Docket Item # 2 & 3  
BAR CASE # 2010-0326/329

BAR Meeting  
January 5, 2011

**ISSUE:** Permit to Demolish/Encapsulate, Signage and Alterations (New Storefront)

**LOCATION:** 719 King Street

Figure 6. Third (current) submission for new storefront.

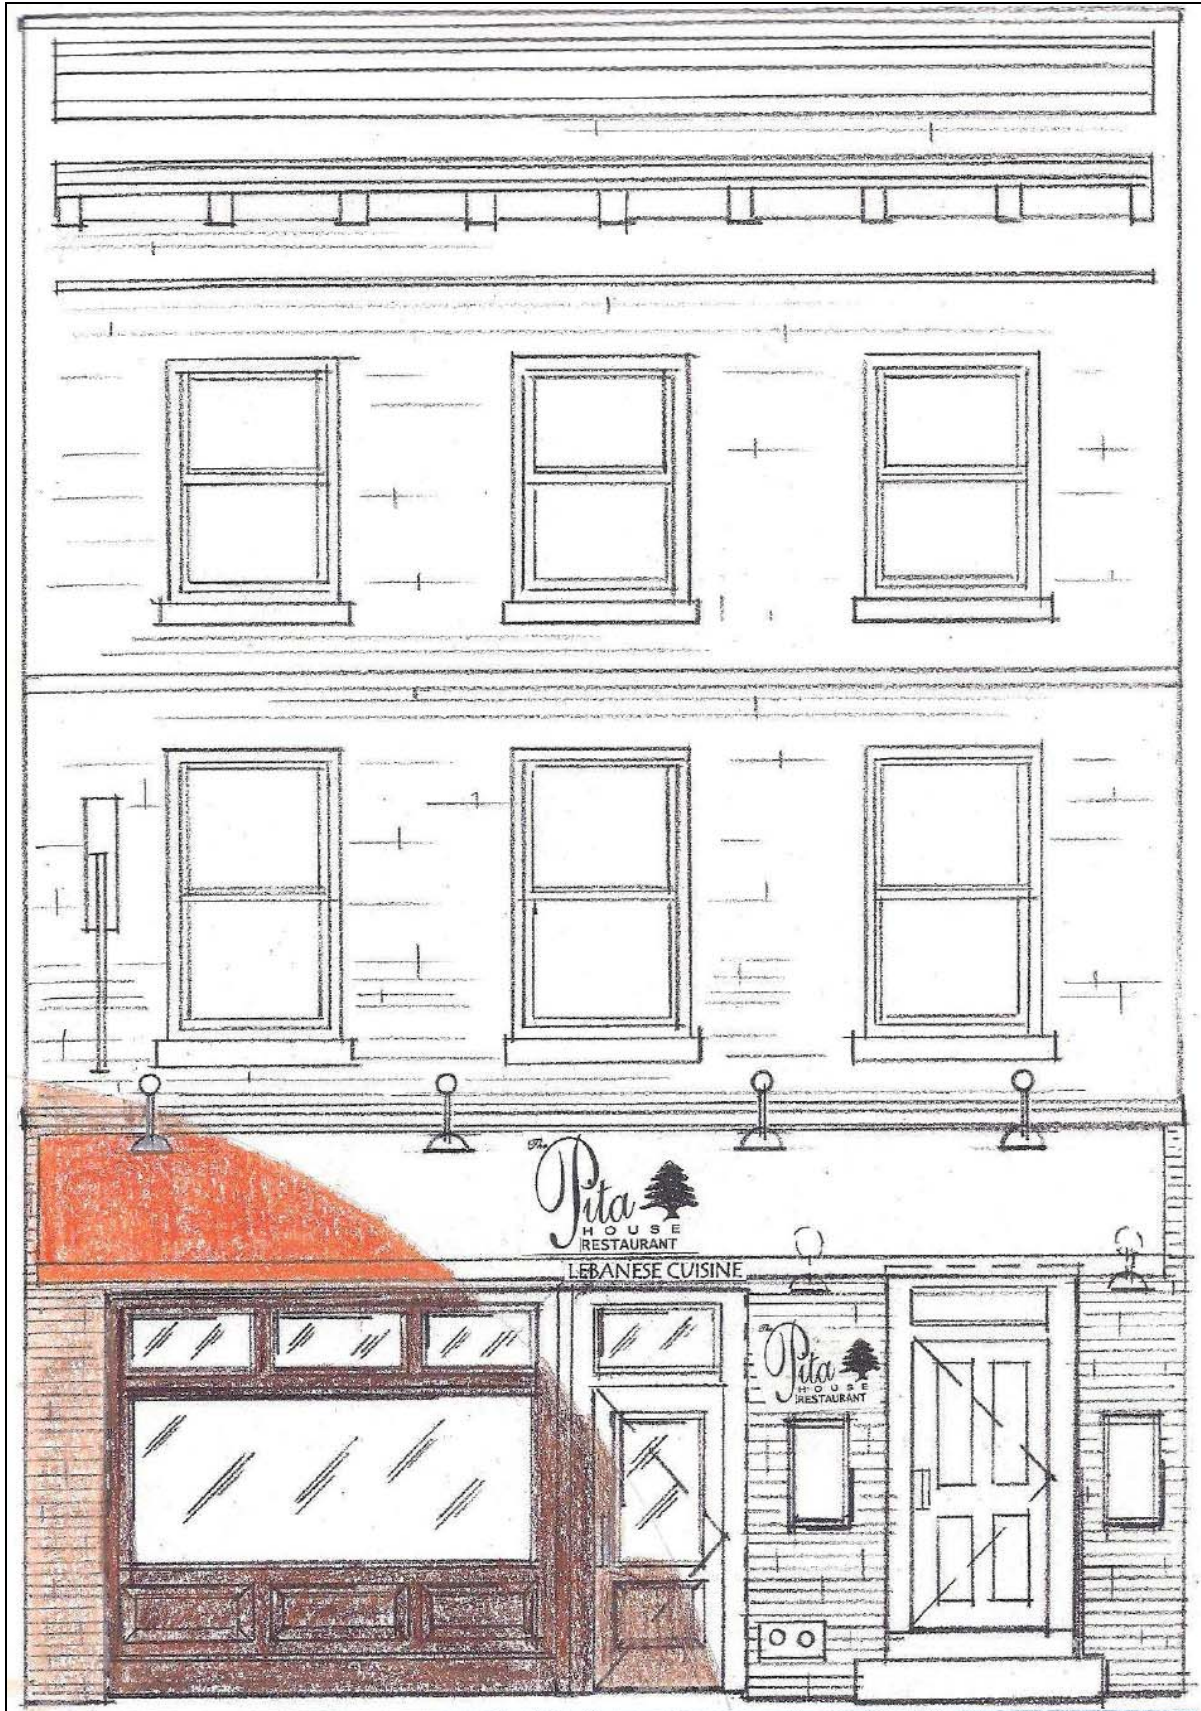
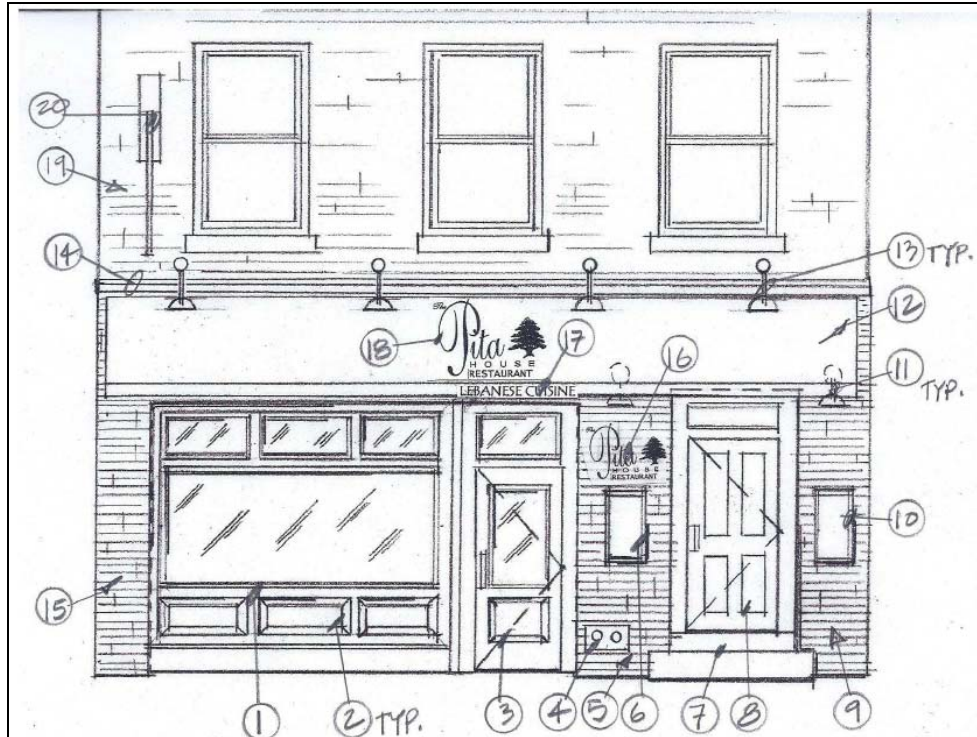
1. That the existing unused metal scroll bracket at the second story be removed from the building.
2. That the awning and signage be anchored through the mortar joints rather than into the brick.
3. That the applicant select a more discreet light fixture to illuminate the storefront and entrance under the awning, with final approval by Staff.
4. That the new metal door on the rear be painted oxide red to match the adjacent brick wall.
5. That all of the proposed aluminum on the storefront be replaced with wood or a wood composite that is millable, paintable and solid through the core.

The applicant and his architect met with BAR Staff prior to filing an application and twice revised the scheme to address concerns raised by the Planning & Zoning Staff. **After the Board's deferral at the December 15, 2010 hearing, Staff met with the applicant again to revise the design to address the Board's concerns.** The initial scheme, as shown in the images section of this report, illustrates the evolution of the design from a bifurcated pair of visually competing entrances to a much simpler, more unified ground floor elevation which whose forms are more compatible with the very simple historic façade above.

While the scope of the proposed changes to the storefront is significant at the street level, Staff is not concerned the integrity of the building will be compromised as a result of the proposed alterations. Although the retention of historic materials is a central tenet of historic preservation philosophy, Staff notes that the existing storefront has been so altered that little, if any, historic fabric will be lost with the installation of a new storefront. The proposed scheme retains all of the original portions of the front elevation, as well as the 1920s Beaux Arts style cornice. The proposed design also uncovers portions of the historic brick wall at the first story and allows the weight of the brick structure to be visually transferred to the ground so that it is not floating above a glass storefront. In addition, storefronts are a building feature typically altered over the life span of a building as they are modified to accommodate changing commercial needs. Staff initially supported the proposed aluminum and glass storefront system finding that while distinctly modern, it allowed one to "read" the evolution of the building over time. In addition, this type of storefront system can easily be reversed. **The Board found that the proposed aluminum storefront scheme was too modern and not compatible with the building and the district, and advised the applicant to look to a more traditional, wood storefront. While the design has become more traditional with the use of transoms and a paneled base, and the alignment and proportions of the menu boards, doors, transoms and panels are significantly improved, the applicant again proposes to use aluminum. Staff understands that a wood storefront has the potential to deteriorate at the base due to splashing and therefore would support wood composite trim, panels and framing that are millable, paintable and solid through the core.**

Figure 13. Existing rear (north) elevation from alley and proposed alterations.

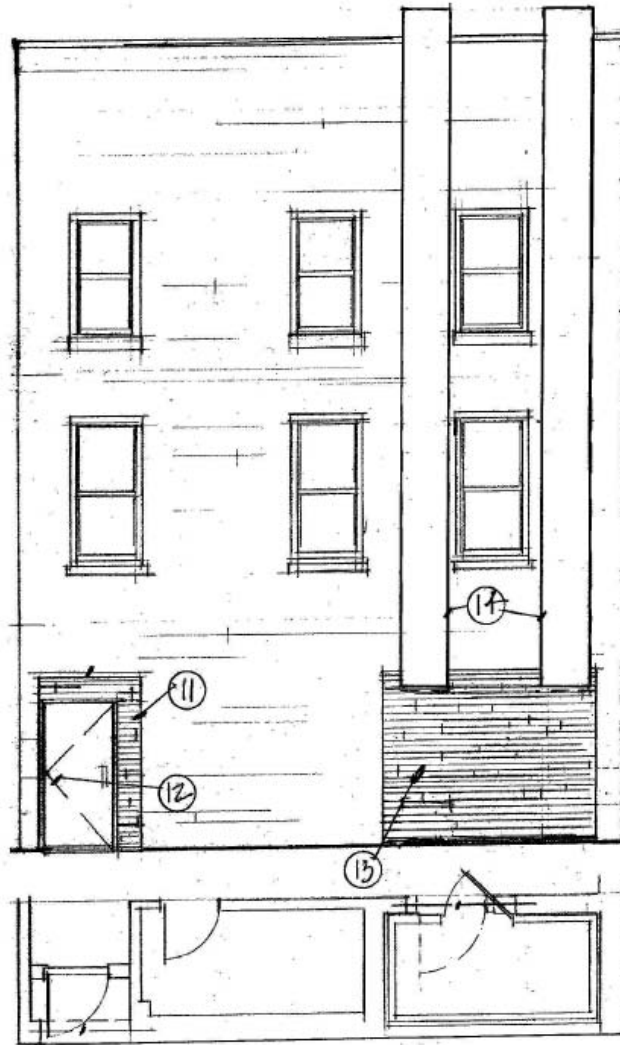
The use of a new flush metal door for the rear fire egress is consistent with the Board's previous decisions on the rear of commercial buildings. Many commercial buildings on King and Washington streets have metal doors on the rear elevations. Although the *Design Guidelines* state that "exterior flush or paneled metal doors may be appropriate in certain limited circumstances for 20<sup>th</sup> century retail, commercial and industrial buildings," Staff finds that this metal door, on what appears to be a 20<sup>th</sup> century addition at the rear of this building, will be minimally visible and is architecturally appropriate for this utilitarian location. Staff, nevertheless, recommends that the door and frame be painted an oxide red color to match the adjacent brick wall.

C-3 Identify size and material for lintel over new door opening in rear wall
